**SUBJECT: REVISION "B" TO ALERT SERVICE BULLETIN 206L-98-114:  
TAILBOOM 206-033-004-ALL, INSPECTION OF.**

NO. 206L-98-114  
DATE 11-25-98  
PAGE 1 of 4

**SUBJECT:** TAILBOOM 206-033-004-003, /-011, /-103, /-045, /-143, /-175 AND /-177 INSPECTION OF. B.

**Figure 1. Inspection of the Tailboom Assembly**

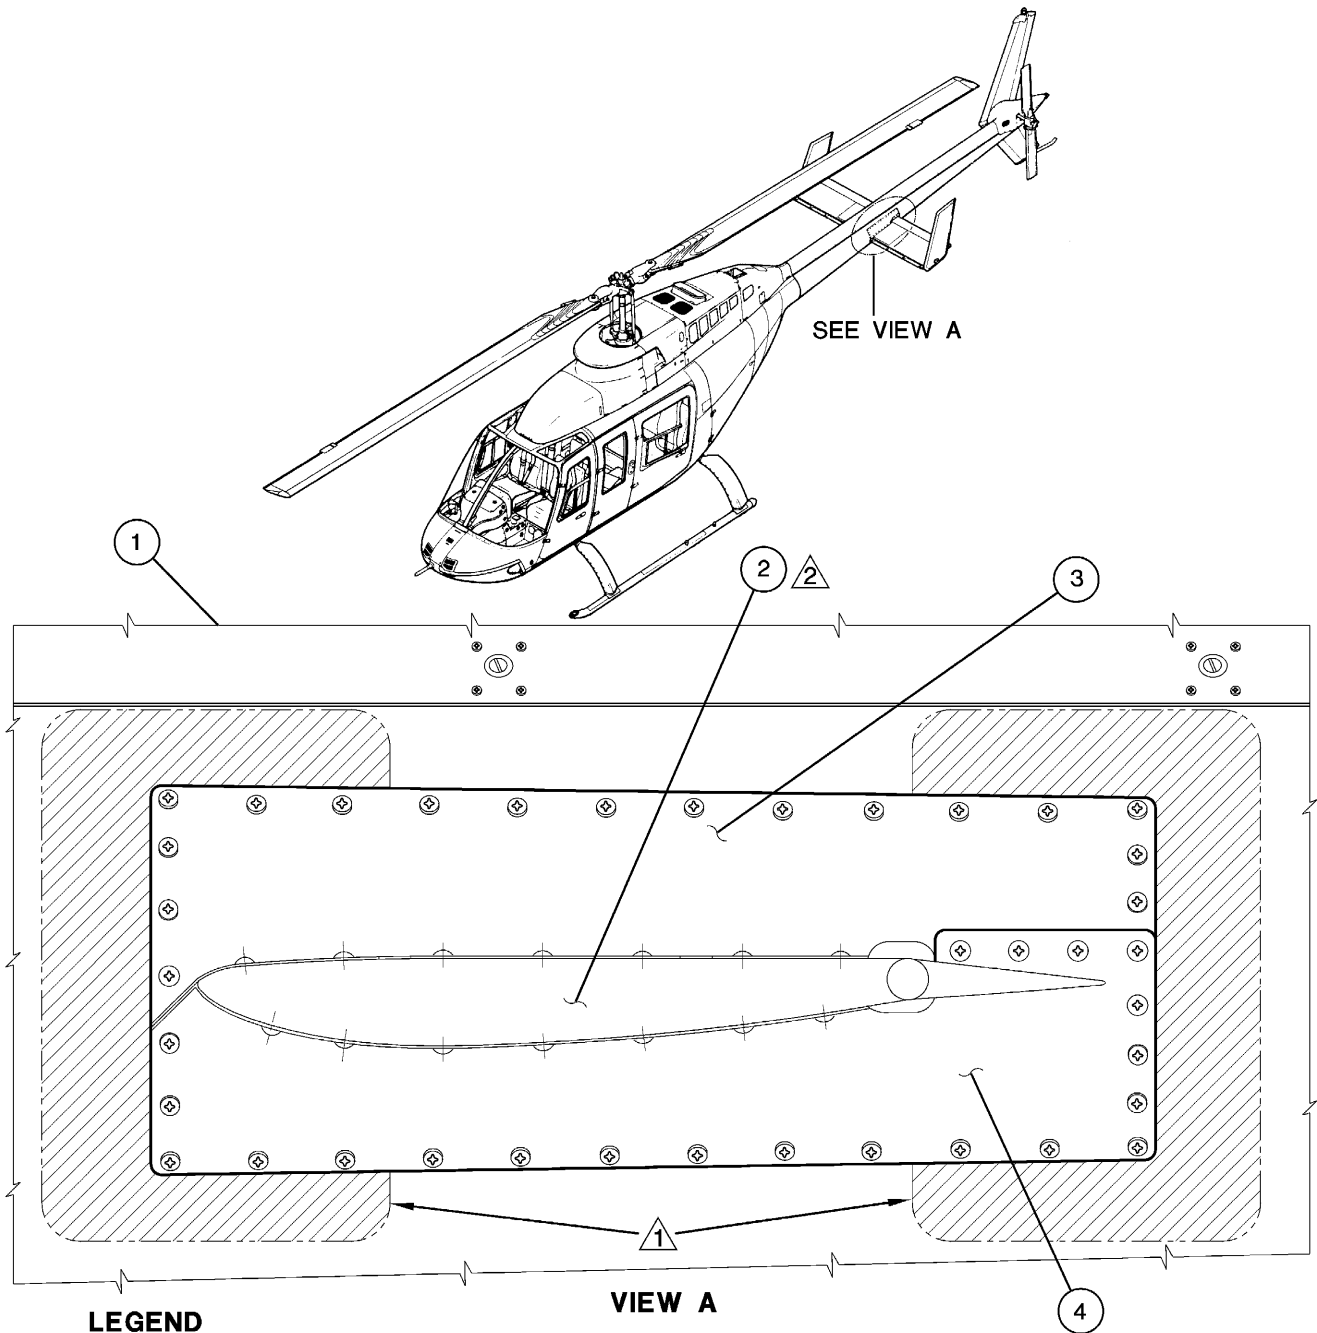
2. Before the first flight of the day, do a check of the tailboom assembly for cracks (Figure 1).
  - a. If there is a crack on the tailboom skin, replace the tailboom before the next flight.
  - b. If no crack is found, the aircraft is serviceable.
3. Make an entry in the helicopter historical records to show that this bulletin is completed.

- △1 Inspect these two areas for cracks on both sides of the tailboom.
- △2 Horizontal stabilizer not shown for clarity.
